**SOIL/SITE EVALUATION
 for ON-SITE WASTEWATER SYSTEM**

- PLOT PLAN FOR -
CAVINNESS LAND

WOODSHIRE SUBDIVISION-PHASE FIVE

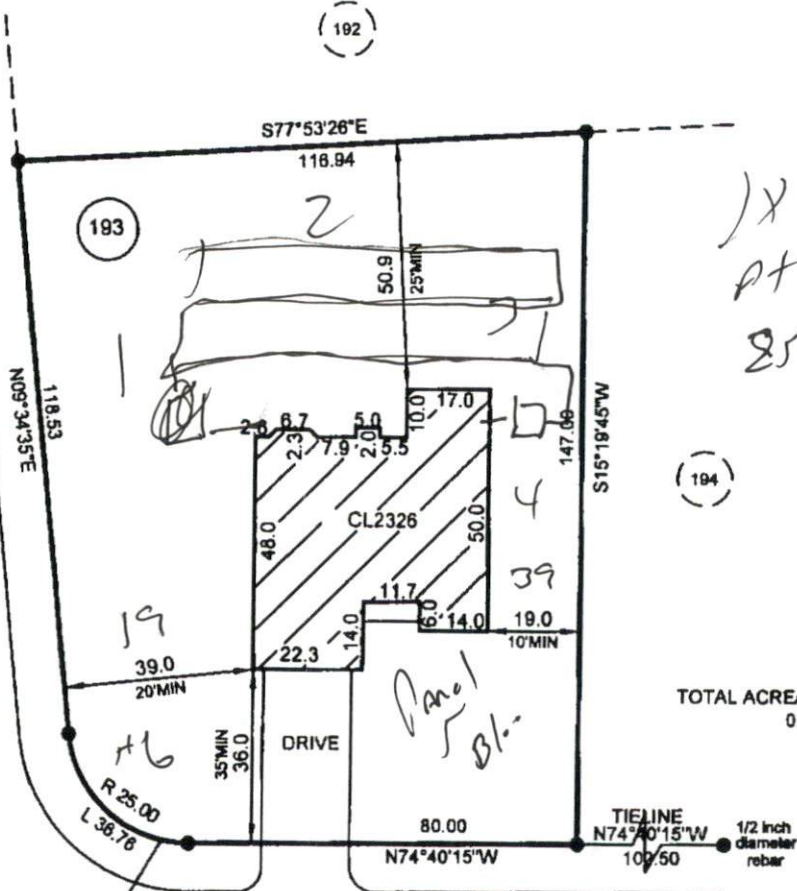
*Move
house
see
Bad*
